Office Action Summary	Application No. 09/801,409	Applicant(s) ROHILLA, GAJENDER	
	Examiner ARMANDO RODRIGUEZ	Art Unit 2828

DETAILED ACTION

The Bednarz et al reference pertains to a semiconductor laser driver circuit.

Fig. 3

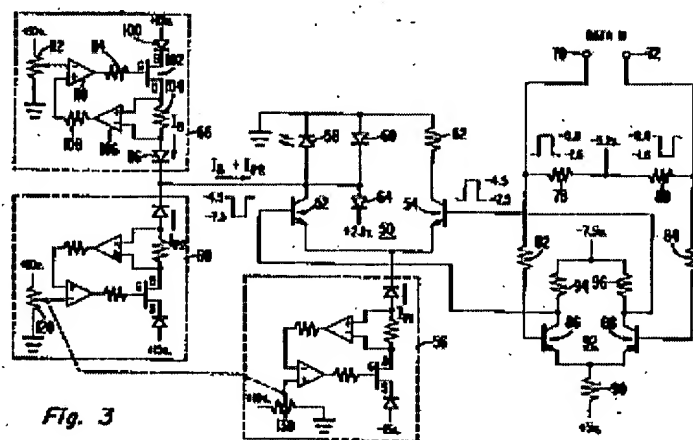
Regarding claim 8,

Figure 3 illustrates a circuit having two transistors (52) [applicant's first transistor] and (54) [applicant's second transistor], where the transistors each receive an input signal [applicant's two inputs], a constant current source (56) [applicant's first current source], which is connected to both transistors (52) and (54), a constant current source (68) [applicant's second current source], which is connected to transistor (52), as described in column 3 line 53 to column 4 line 3. Column 3 line 67 to column 4 line 1 and column 5 lines 42-43, describes the constant current sources (56) and (68) as substantially equal. As illustrated in figure 3 and described in column 3 line 53 to column 4 line 3, current source (56) provides a first current, current source (68) provides a second current and current source (66) provides a third current, where the second current and the third current which is substantially equal to the second current minus the first current will be delivered to the laser diode (58).

Figure 3 illustrates the use of Bipolar transistors, as described in column 3 lines 53-57 as NPN transistors.

Figure 3 illustrates the inputs connected to the base of the transistors (52) and (54), as described in column 4 lines 40-42.

Figure 3 illustrates current source (56) connected to the common emitters of the transistors (52) and (54), as described in column 4 lines 1-3.

Figure 3 illustrates current source (68) connected to the collector of transistor (52).

Figure 3 illustrates a semiconductor laser diode (58), as described column 3 line 61.

Figure 3 illustrates the laser diode connected to the collector of transistor (52).
